Model: Stella-C1		Date: 9-Jan-02	No.: RB044001
Subject: PS2 Option		Prepared by: K. Ugaeri	
From: Technical Services Dept., GTS Division			
Classification:	<input checked="" type="checkbox"/> Troubleshooting <input type="checkbox"/> Mechanical <input type="checkbox"/> Paper path <input type="checkbox"/> Other (      )	<input type="checkbox"/> Part information <input type="checkbox"/> Electrical <input type="checkbox"/> Transmit/receive	<input checked="" type="checkbox"/> Action required <input type="checkbox"/> Service manual revision <input checked="" type="checkbox"/> Retrofit information

Subject: Optional Printer Controller		Prepared by: A. Ishiyama	
From: Technical Services sec. Service Planning Dept.			
Classification:	<input checked="" type="checkbox"/> Troubleshooting	<input type="checkbox"/> Part information	<input checked="" type="checkbox"/> Action required
	<input type="checkbox"/> Mechanical	<input type="checkbox"/> Electrical	<input type="checkbox"/> Service manual revision
	<input type="checkbox"/> Paper path	<input type="checkbox"/> Transmit/receive	<input type="checkbox"/> Retrofit information
	<input type="checkbox"/> Other (       )

Model: Stella-C1		Date: 05-Ap

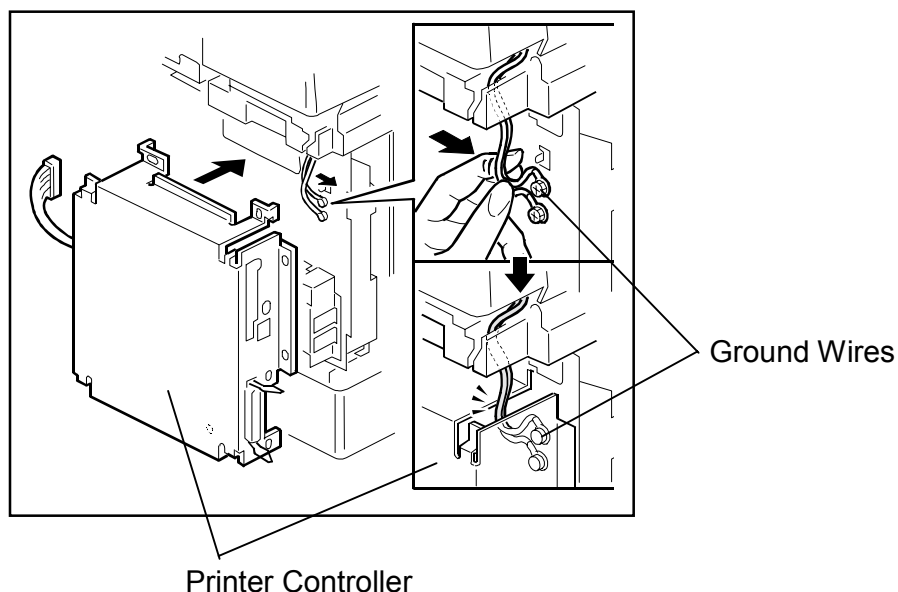
After installing the printer controller in Step 5 of the Installation Procedure, the ADF unit does not open all the way.

When the Controller was installed, the 2 ground wires were not led through the inlet (opening) in the upper right corner of the controller bracket, causing excess tension on the wires.

When installing the Printer Controller, be sure to set the wires into the opening in the upper right part of the bracket as shown below. This will prevent excess tension on the wires and allow the DF to fully open.

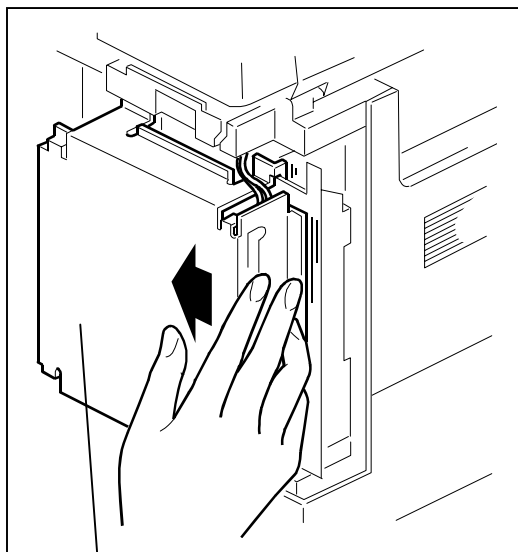
After installing the Printer Controller in Step 5 of the Installation Procedure, the 3 screw holes on the main face of the Rear Cover do not line up with the mainframe holes, making it difficult to reattach the cover.

When the Controller is attached slightly right of center, the width and circular (top) screw holes of the Rear Cover do not provide enough clearance for left/right cover adjustment, and the two contact one another.

When attaching the Controller, hold it flush to the left while tightening the bracket screws as shown in the illustration below.

The shape of the upper screw holes on the main face of the Rear Cover will be changed from circular to elliptical (running change) to allow for any necessary left/right adjustment.

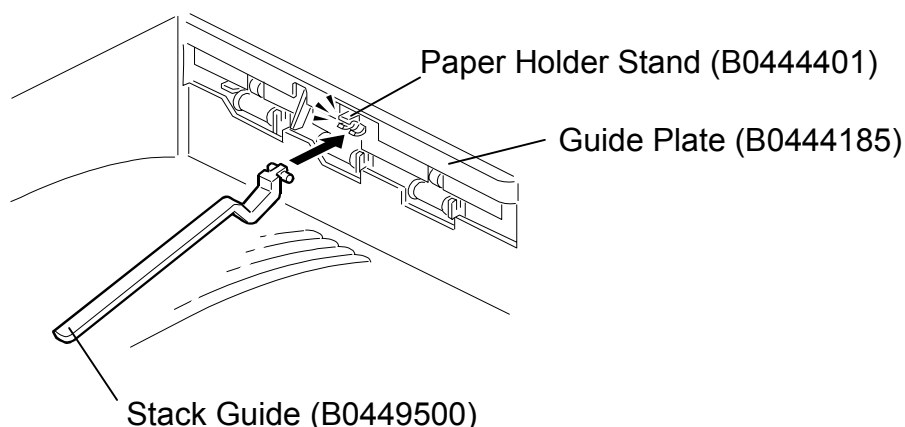
Occasional paper jam at the exit area when using paper that curls easily (e.g. thin paper).

During the copy process, the leading/trailing edges of the paper sometimes curl downward, which can prevent proper stacking and cause a jam.

A Stack Guide (P/N **B0449500**) has been registered as a service part, which will allow the paper to stack properly even if it is curled downward.

As shown below, the Stack Guide should be set on the Paper Holder Stand (B0444401), which is attached to the Guide Plate (B0444185) in the paper exit area.

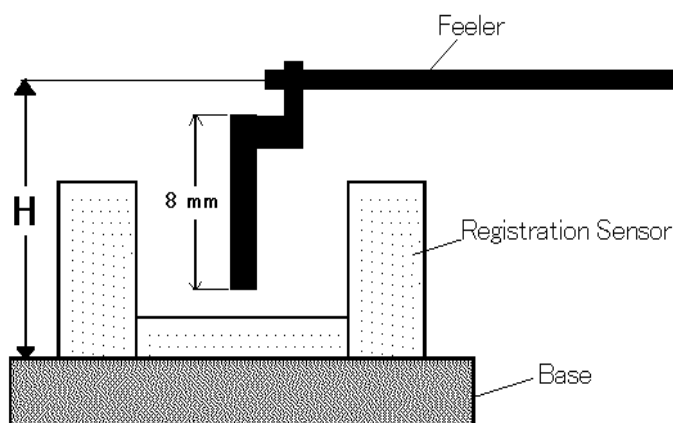
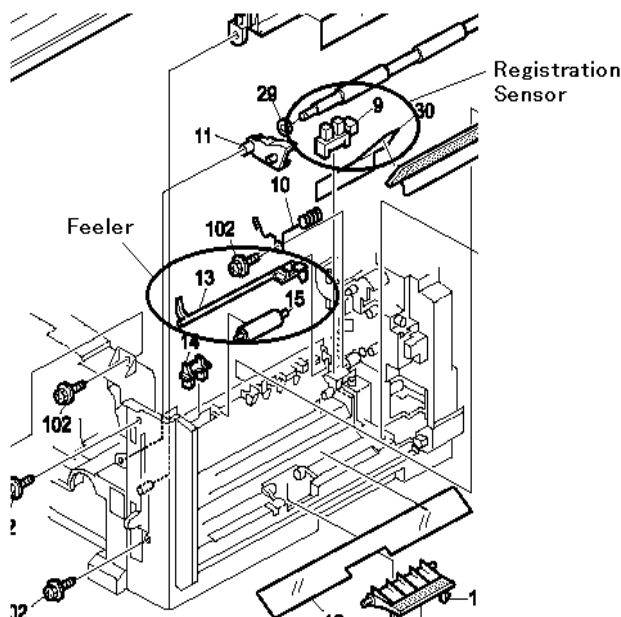
"Clear misfed paper" is mistakenly displayed. This can occur after printing, when turning on the power, and/or in standby mode.

A misdetection by the registration sensor (#9 in the illustration below) is interpreted by the machine as a paper jam. The misdetection occurs when dimension H below is slightly longer than ideal, preventing the sensor feeler (#13, P/#: B0442603) from shutting correctly. This feeler was located too high because of a fault in the mold used to make the base.

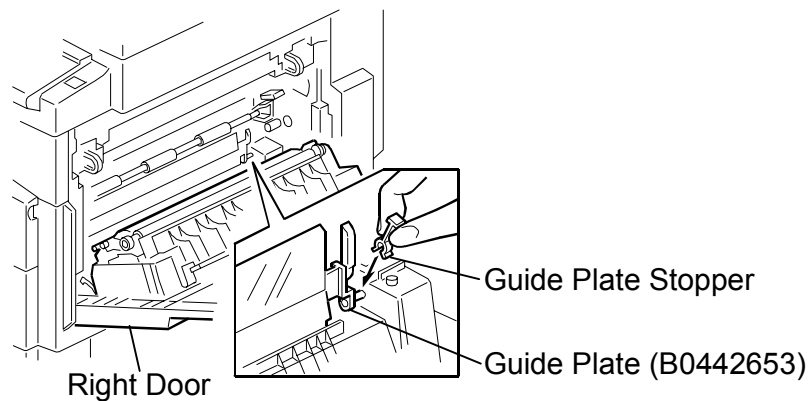
The Paper Feed Guide Plate (B0442653) disconnects from the pivot area.

Attach a Guide Plate Stopper as shown below.

## Fixing the Side Fence in Place

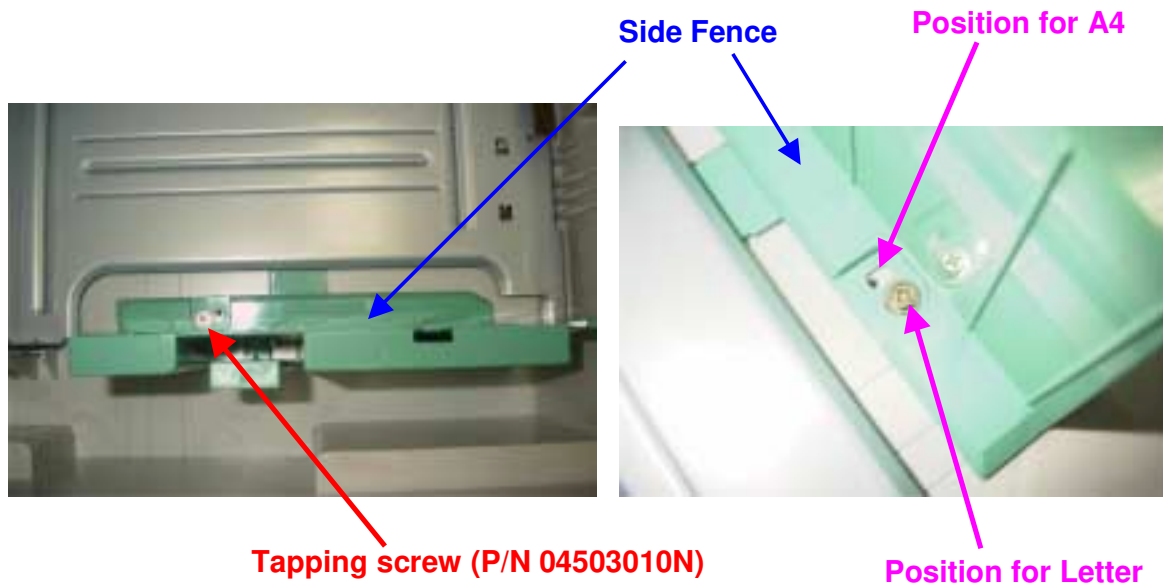
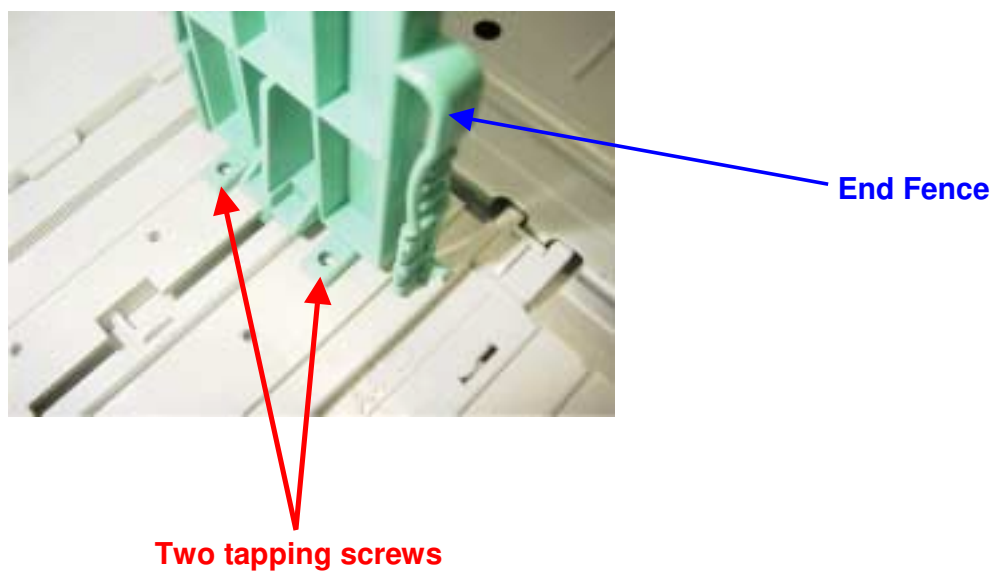
Non-feed jam in the optional paper tray unit.

The side fence can shift inward when the operator loads the paper incorrectly (e.g. not fanning the stack, not placing it in the tray gently), which can then tighten the fence's hold on the paper and make it difficult to feed.

After gaining the consent of the customer, please fix the side fence to the base of the cassette using one tapping screw.  
 (See the photos on the next page).

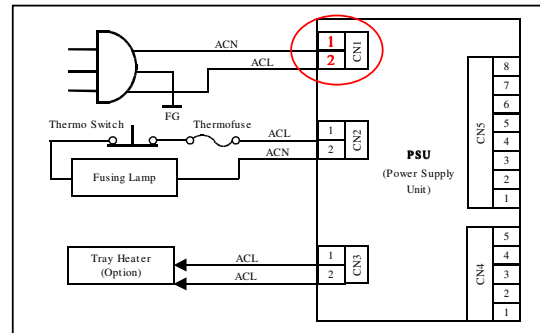
The P-to-P diagram for machines produced up until October is different from the P-to-P diagram for machines produced from November. Please keep two separate P-to-P diagrams, as shown below:

- P-to-P for machines **up until October**: Should show the hot and neutral lines in the **wrong** position (reversed).
- P-to-P for machines **from November**: Should show the hot and neutral lines in the **correct** position.

**Up Until October 2004:**  
Wrong Position (reversed wiring)

**From November 2004:**  
Correct Position (original wiring)

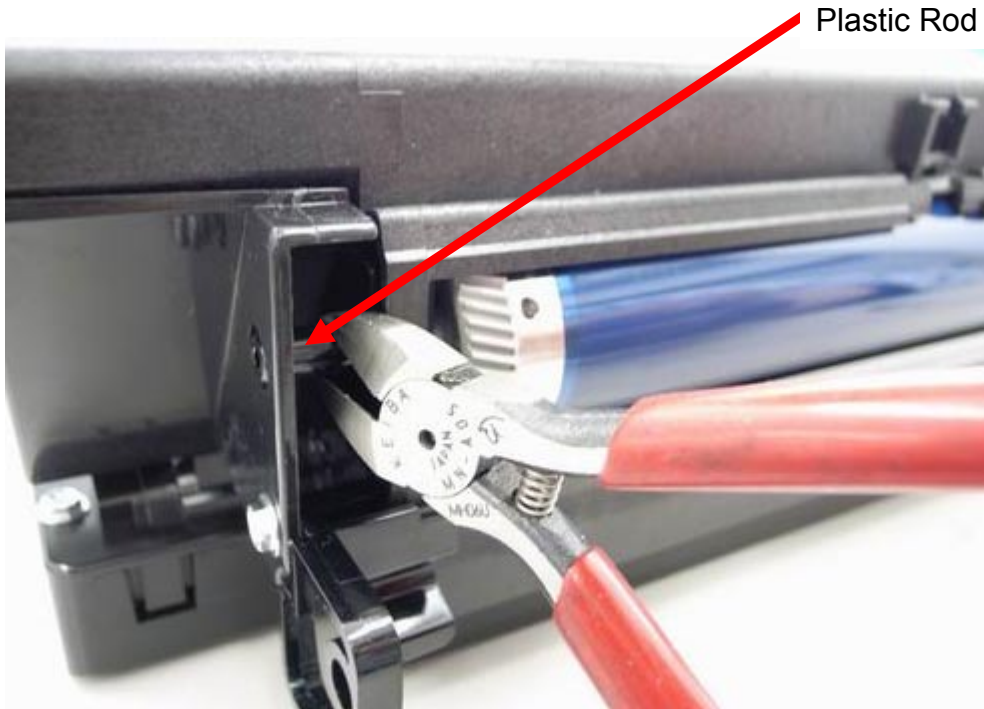
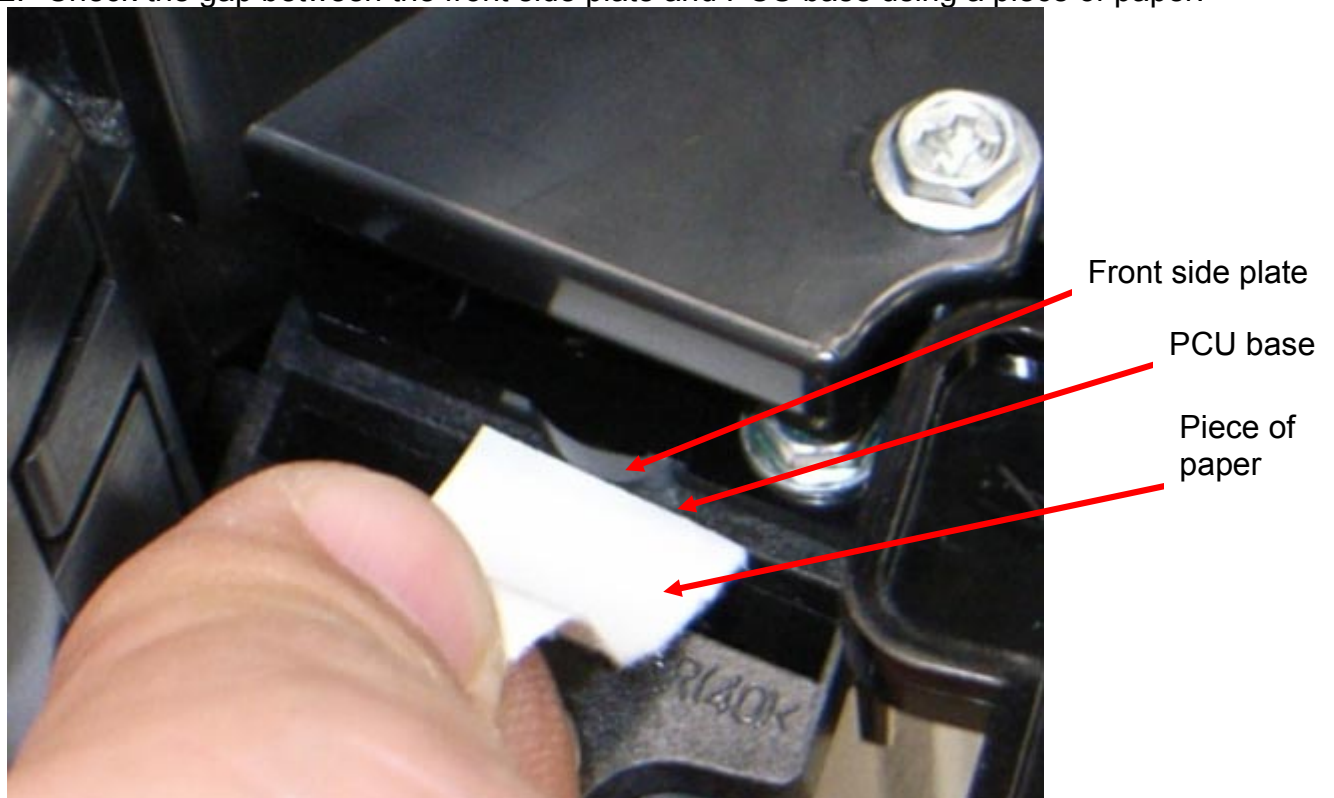
The PCU assembly process was modified as follows:

- A step was added to ensure that there is no gap between the front side plate and PCU base.
- The plastic rod on the PCU front side plate will be removed (cut).

1. Cut and remove the plastic rod using a pair of needle-nosed pliers.
